Staff Briefing Papers

Company Northern States Power Co. d/b/a Xcel Energy

Docket No. E002/CI-24-318

In the Matter of a Commission Inquiry into a Framework for Proactive Distribution Grid Upgrades and Cost Allocation for Xcel Energy

Figure 4: Comparison of Cost Share Window Options

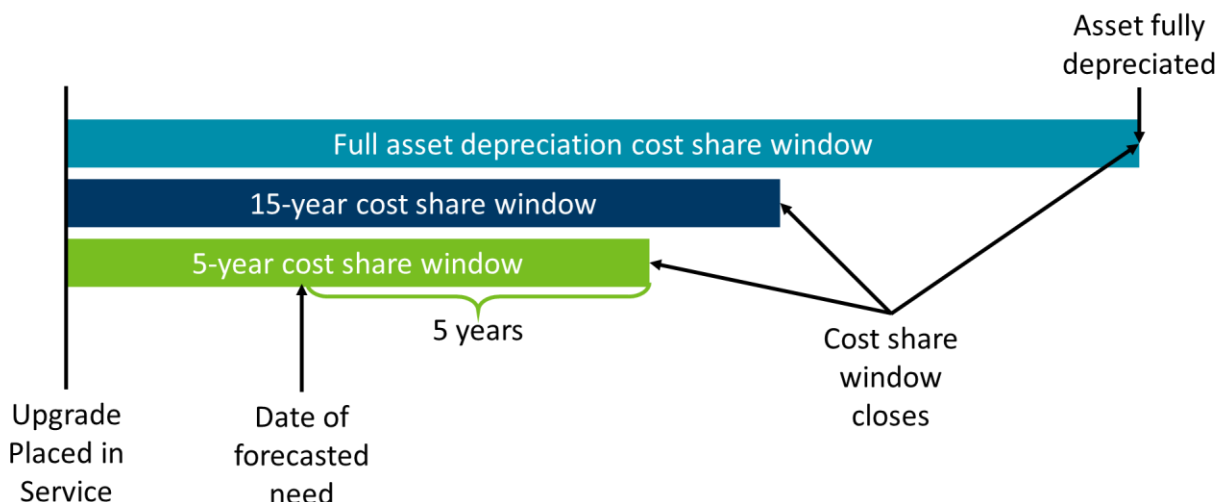
Under both the “full asset depreciation” and 15-year option the cost share window opens when the upgrade is placed in service. Under the 5-year option, the window opens when the upgrade is placed in service, but the countdown to the end of the cost share window does not open until the date when the utility’s forecast indicated a need for the upgrade.

Figure 7: Planning Limit Comparison

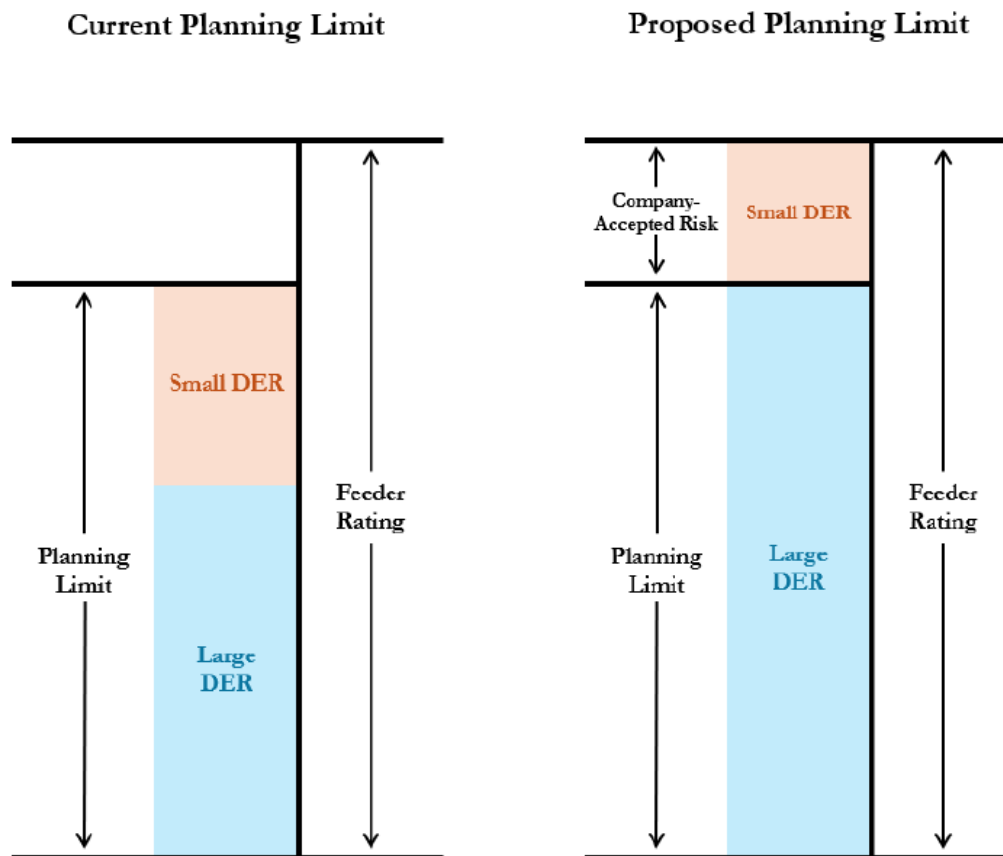
Xcel recommended adoption of its preferred capacity reservation system encompassed in L.4 and L.4.a. Under the Company's proposal, it would modify its existing Technical Planning Standard (TPS) to allow distributed generation that qualifies for its Priority Queue¹⁷⁵ to exceed the existing TPS up to the distribution equipment's thermal rating.¹⁷⁶ This change is depicted in Figure 7.

The Company explained that while exceeding the planning limit creates risks to the distribution system, when this exceedance is limited to small DERs that are associated with localized load it mitigates a portion of the impacts. The Company also explained this would be a temporary state, as under both the Proactive Distribution Upgrade Program and the forthcoming Reactive Cost Share Program, the Company would have mechanisms to remedy the situation. Xcel outlined the following benefits to its proposed capacity reservation:
